PIC32MZ EF FAMILY

PIC32MZ Embedded Connectivity with Floating Point Unit (EF) Family Silicon Errata and Data Sheet Clarification

The PIC32MZ Embedded Connectivity with Floating Point Unit (EF) family of devices that you have received conform functionally to the current Device Data Sheet (DS60001320), except for the anomalies described in this document.

FIGURE 1: Posc CRYSTAL CIRCUIT

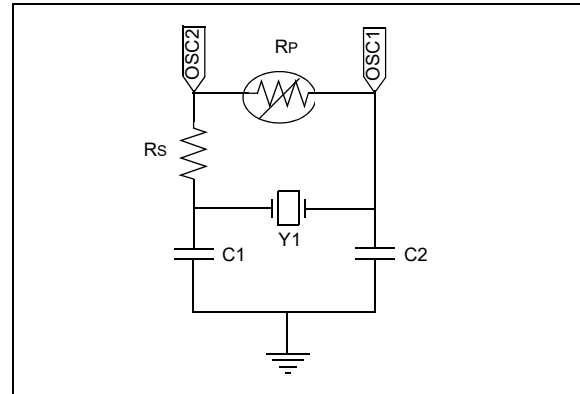
Revision A3 and B3 Silicon: The POSC has been tested in a normal power-up sequence and supports specific crystal operation.

The Primary Oscillator (Posc) has been characterized to operate at 8 MHz, 12 MHz, and 24 MHz when the circuit in [Figure 1](#) is implemented, and the operating conditions listed in [Table 3](#) are met.

64-PIN QFN⁽⁴⁾ AND TQFP (TOP VIEW)

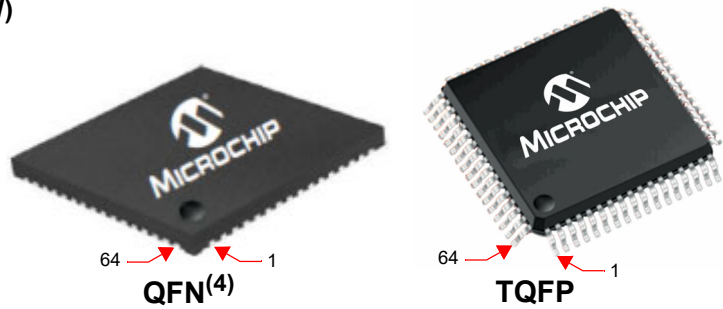
In Table 2. “Pin Names for 64-pin QFN and TQFP Devices” of the current data sheet, the AECRS_{DV} signal was erroneously omitted from the pin number 44 and added to the pin number 62. The correct assignment is shown in bold type in the following table.
